# Intel<sup>®</sup> 440BX AGPset: 82443BX Host Bridge/Controller

Specification Update

*January 2001*

Document Number: 290639-006

Figure 5. Waveform of NANDtree Chain Pair up (A4 and A8) and (A5 and A9)

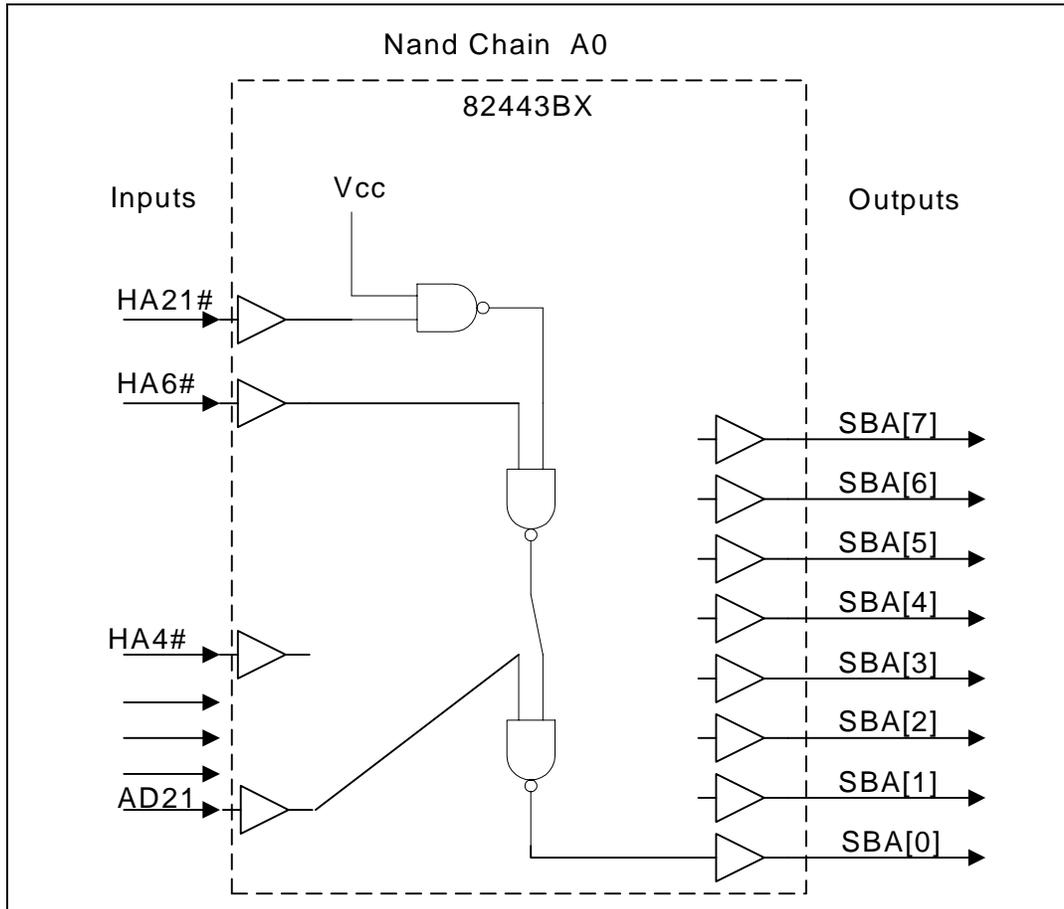
To repair the NAND tree test of Chain #A5/#A9 (MMO enabled) for the 82443BX C1 stepping, remove DCLKRD from the test and invert the expected data for all pins (MAA13, MAA7, CKE5, CKE1, MAA12, MAA11, MAA3, MAA10, MAA1, MAA9, MAA8, MAA5, MAA6, MAA4, MAA2, and MAA0) which were tested following the DCLKRD pin.
